S4.55 (1A) MODIFICATION

MODIFICATION TO AMEND THE APPROVED CATHOLIC COLLEGE (SSD 8989)

2 KINGFISHER CLOSE AND 507 MEDOWIE ROAD, MEDOWIE
(LOTS 412 AND 413 DP 1063902)

DATE: 27 MARCH 2025

Figure 3: Extract of Stormwater Plan (source: MPC)

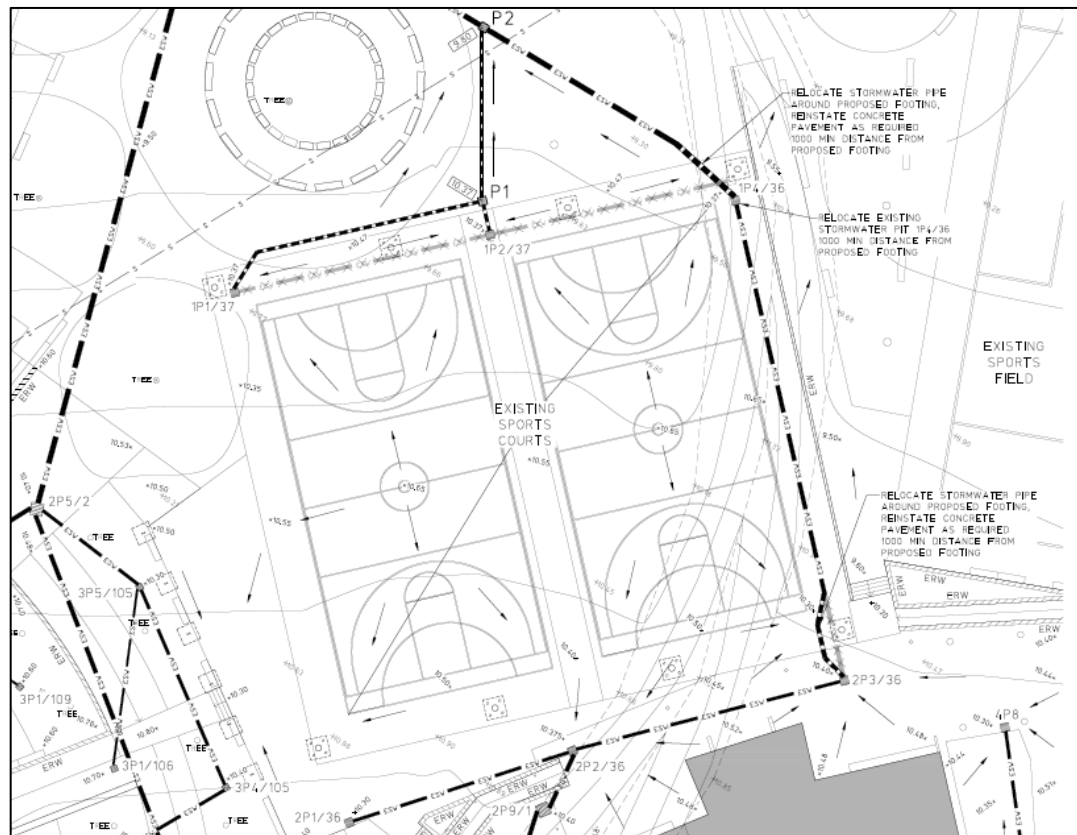
The application seeks the provision of a COLA structure between Blocks E and J over the two existing high school basketball courts. It will consist of a metal pitched roof supported by 8 posts. At its highest point the structure creating the COLA will be 10m high with dimensions of 45.86m x 36.6m.

LED Highbay lighting. Further details are provided in **Appendix 4** and **5** and *Figures 3* and *4* below.

- The changes to the existing stormwater system will prevent conflict with the footings of the proposed COLA.
- Tree 36 will suffer significant canopy intrusion (40%) such that its long-term retention is not possible. The removal of this tree has been considered arboriculturally and requires removal.
